and Management Parameters for 10 Mb/s Operation and Associated Power Delivery over a Single Balance

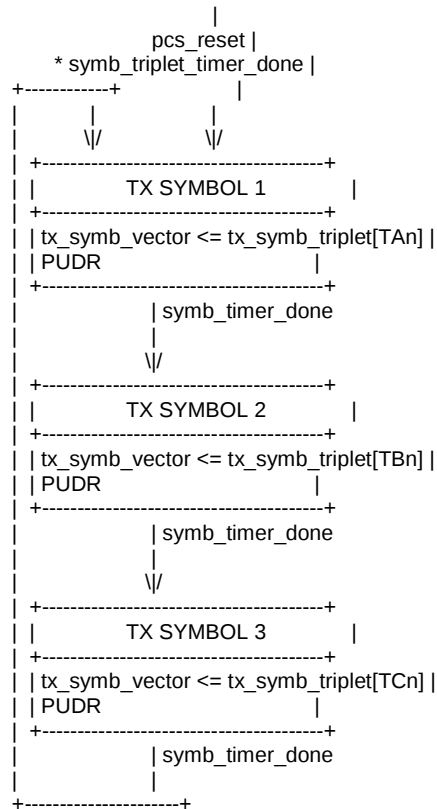
Cl 146	SC 146.3.3	P 117	L 18	# i-342
Law, David Hewlett Packard Enterprise				
Comment Type	TR	Comment Status	X	
Is it correct that 'The PCS Transmit function shall conform to the PCS Transmit state diagram in Figure 146-5 ...' and that 'In each symbol period, PCS Transmit generates a symbol An provided to the PMA ...'? The PCS Transmit state diagram in Figure 146-5 changes state based on STD being true, with STD being an alias for symb_triplet_timer_done, and the output of the PCS Transmit state diagram is tx_symb_triplet which is defined in subclause 146.3.3.1.1 'Variables' as 'A triplet of ternary symbols generated by the PCS Transmit function after 4B3T encoding.'

I think the problem is that there is another function within the PCS Transmit function that is missing from the PCS Transmit state diagram in Figure 146-5, the 'multiplexor' shown in Figure 146-6 'PCS transmit symbol generation'. This 'multiplexor' function operates at the symbol clock rate and serialises the tx_symb_triplet code-groups output by the PCS Transmit state diagram into individual symbols.

This may also explain when subclause 146.3.3.1.3 'Timers' defines the symb_timer that is not used in the PCS Transmit state diagram in Figure 146-5.

tx_symb_triplet{TAn, TBn, TCn}

A triplet of ternary symbols generated by the PCS Transmit state diagram. The element TAn is the first ternary symbol transmitted; TCn is the last ternary symbol transmitted.
Value: A triplet of ternary transmit symbols. Each of the ternary symbols may take on one of the values {-1, 0, +1}.

[4] Add a new subclause 146.3.3.2.2 titled 'Timers'. Move the symb_timer definition from subclause 146.3.3.1.3 Timers to this new subclause.

[6] Insert a new Figure 145-6 shown below (view using a non-proportional font such as courier), renumbering the following figures as required.

[7] Add text to subclause 146.3.3 'PCS Transmit' that reads 'The PCS Transmit function shall conform to the PCS Transmit state diagram in in Figure 146-5 and the PCS Transmit multiplexor state diagram in 146-6, and their associated state variables, functions, timers, and messages.'.
